GFA/AD/20

SLINGSBY 3

AIRWORTHINESS DIRECTIVE GLIDERS.

REFERENCE GFA/SLINGSBY. 1/73/1.

UNDERCARRIAGE REPAIR SCHEME

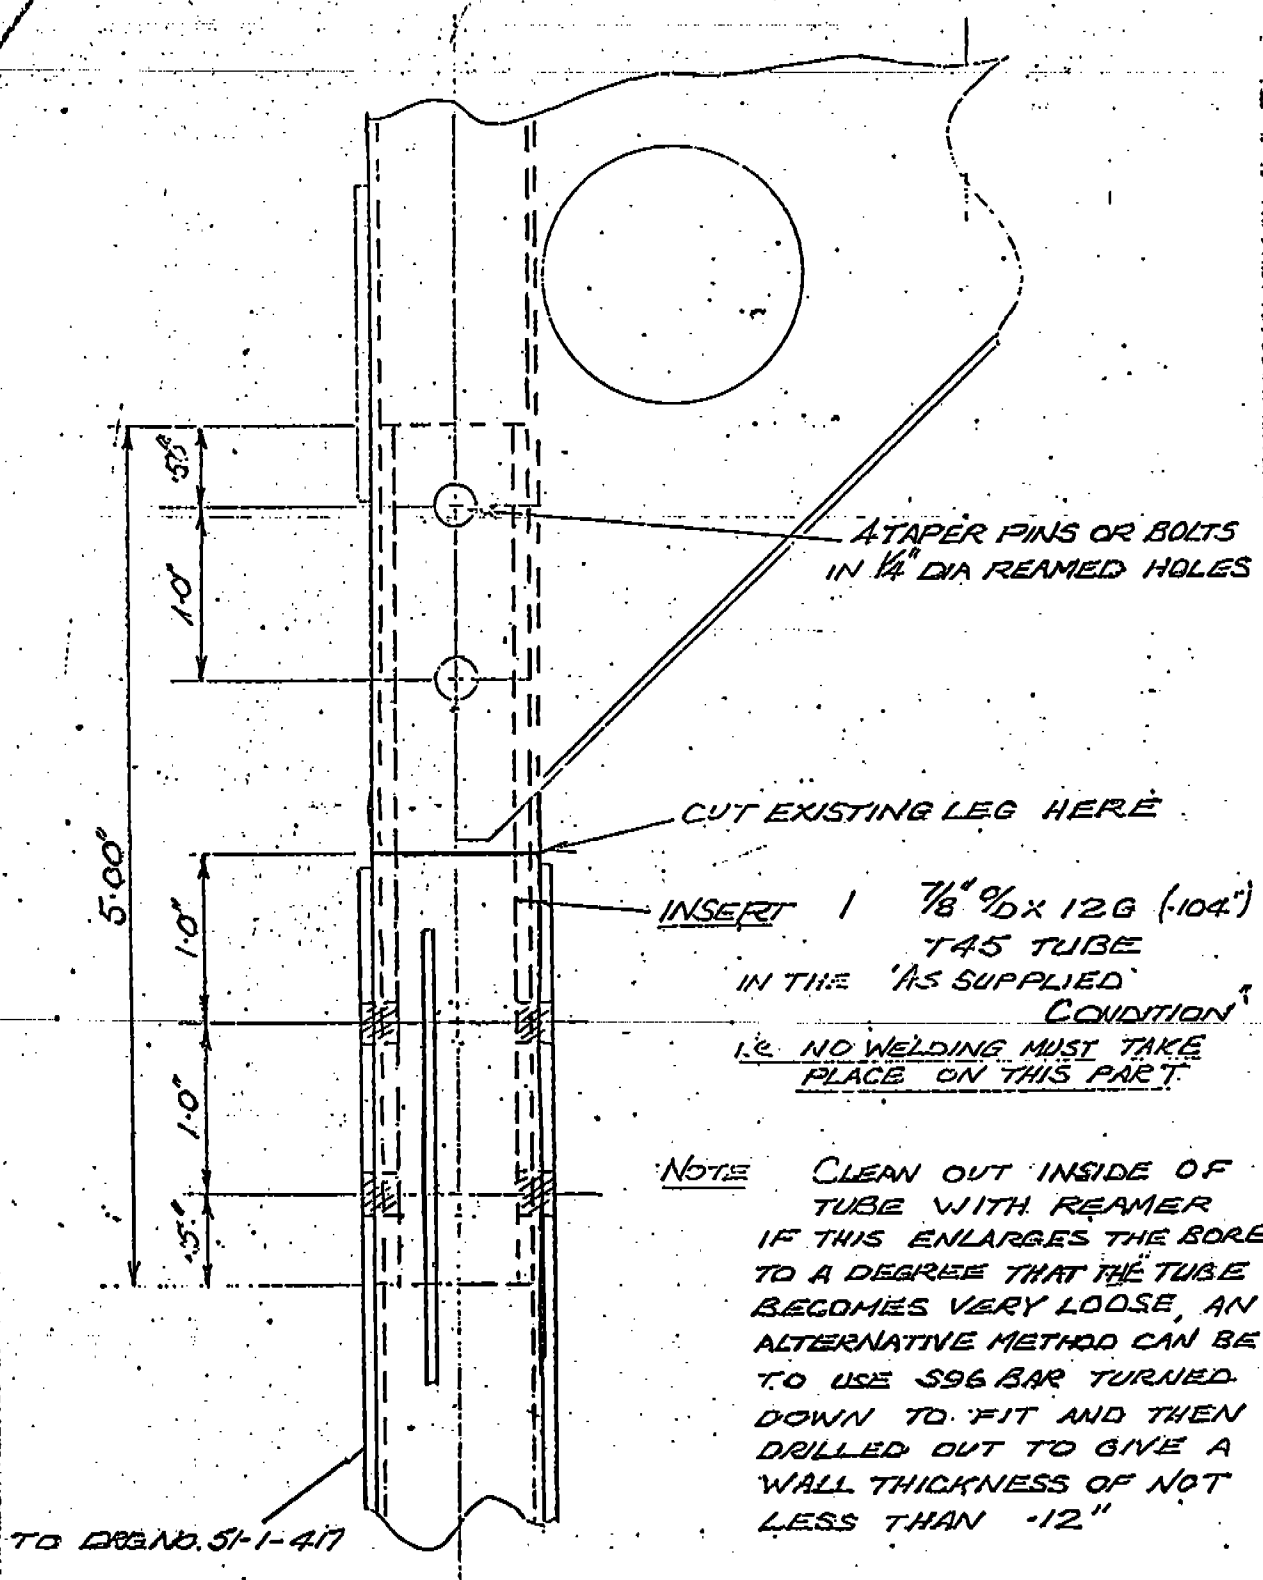
STRENGTHENING OF MANUAL RETRACTABLE UNDERCARRIAGE

Due to a small number of main undercarriage fork failures a design change has been made, introducing strengthening of the Fork.

This modification is in the form of an internal tube inserted into the existing 1.0" ϕ /D Tubes.

1. Remove undercarriage doors.
2. Disconnect wheel brake.
3. Remove Wheel.
4. Remove radius rod bolts.
5. Remove ply skin between longeron and wheel box top in line with undercarriage pivot bolts taking care not to damage longeron. Remove only sufficient to enable nuts to be removed from undercarriage fork pivots.
6. Remove wheel brake lever.
7. Remove undercarriage fork, 51-1-417.
8. Cut existing fork as shown on SK 51/423 (attached).
9. Carry out instructions as per SK 51/423.
10. Fit $\frac{7}{8}$ " O/D 12G. tube inside undercarriage fork as shown.
11. Drill and Ream for 4 taper pins or bolts, each side as shown.
12. Fit taper pins or bolts.
13. Touch up paint on undercarriage as required.

14. Replace undercarriage fork 51-1-417.
15. Replace wheel brake lever.
16. Reconnect radius rod.
17. Replace wheel.
18. Reconnect wheel brake.
19. Replace undercarriage doors.
20. Check operation of undercarriage mechanism.
21. Splice in 2 mm ply skin where removed and finish to existing undercarriage finish.
22. Ensure that tyre pressure is between 20 and 25 P.S.I.
23. Make the appropriate entry into the glider log-book to certify that the modification has been incorporated.

INCREASE IN TAILPLANE MASS BALANCE WEIGHT

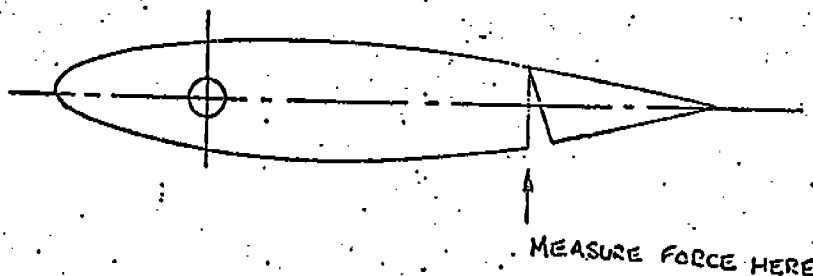
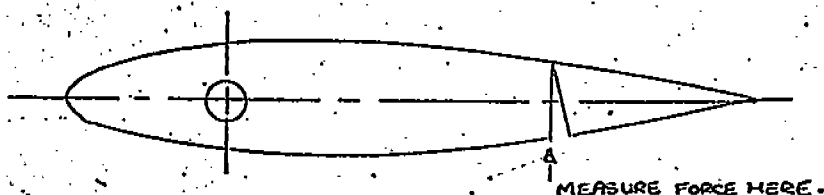
Object of the Modification: It seems likely that, in two or three incidents, Darts have suffered from fairly high-frequency pitching oscillations when flying fast. A detailed analysis of the dynamic stability confirms this possibility and indicates that a larger mass-balance weight for the all-moving tail is required.

Flight tests have confirmed that, when fitted with modified weights, the aircraft has no tendency to oscillate rapidly in pitch, and if such motions are deliberately induced they rapidly damp out.

The modification therefore consists of replacing the present tailplane mass balance weights by larger weights. This modification is to be carried out as soon as possible and in any case before the 31st October, 1967.

1. Remove the two inspection panels forward of the tailplane in the rear fuselage.
2. Remove the existing elevator mass balance weights via the inspection panels.
3. Disconnect the rear end of the elevator push rod from the lever in the rear fuselage.
4. Since there are several different types of "Dart" tailplane, the new balance weights are somewhat too large as supplied, and must be trimmed to suit each aircraft.
5. Fit the new balance weights to the balance weight arm but do not tighten the attachment bolt fully.
6. Fit the tailplanes.
7. Measure the force which has to be applied to the root rib of the tailplane, immediately forward of the leading edge of the tab, to bring the tail to its neutral position.

8. Trim the balance weights, taking roughly equal amounts off each, until the upwards force, measured in the manner described above, is between 1 and 1.25 lb (0.45 to 0.56 kg).

Be careful to allow for the effect of friction by taking the mean of the forces which (a) just allow the trailing edge to rise and (b) just push it down.

ASSEMBLY OF FRICTION DEVICE. DART MOD 67A.

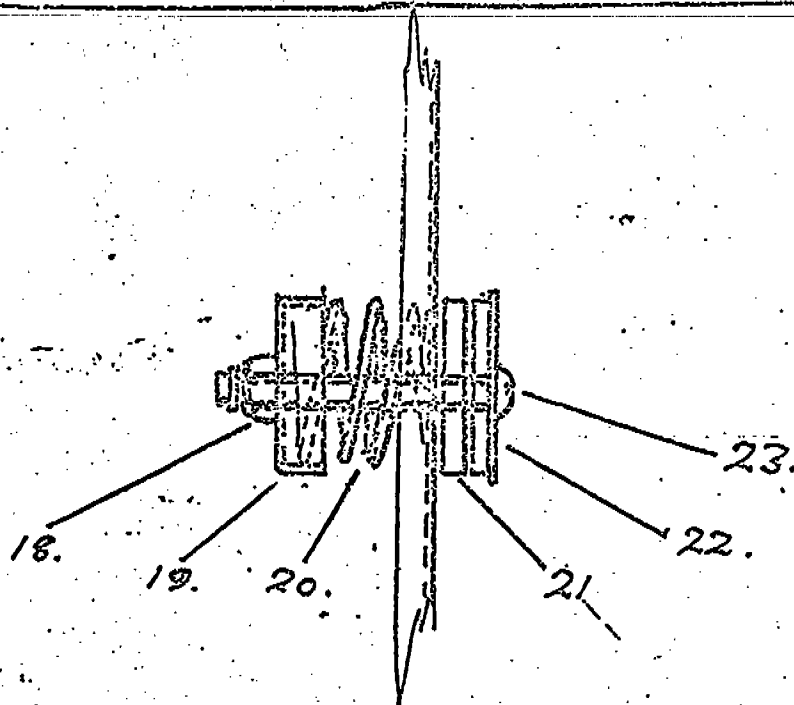
It has been found that whilst there is no difficulty in fitting Dart Modification No. 67 to the later Dart variants with wooden tailplanes it is not practicable to apply it to those with metal tailplanes, nor to some earlier machines with a small range of cockpit load.

This Modification, No. 67A is intended for those aircraft as an alternative to Modification No. 67.

1. Remove the inspection panel in the port side of the fin immediately behind the tailplane axle.
2. Remove the trimmer friction washers of red fibre from the trimmer layshaft, having first removed the 2BA locknut from the back side, and the 2BA round headed securing screw.
3. Remove the anchor nut on the trimmer layshaft by drilling out the two $\frac{3}{32}$ rivets securing same, and apply protective treatment to remaining rivet holes.

4. Fit items 18, 19, 20, 21, & 23 as supplied in Modification kit in accordance with sketch attached. Use existing large dia. $\frac{3}{16}$ " washer removed from old assembly.

Tension in accordance with rigging drawing 51-1-1 Iss. 6 or 7 or 51-1-201 Iss. 8 or 9 whichever is applicable. No grease whatsoever should be present on the friction device.
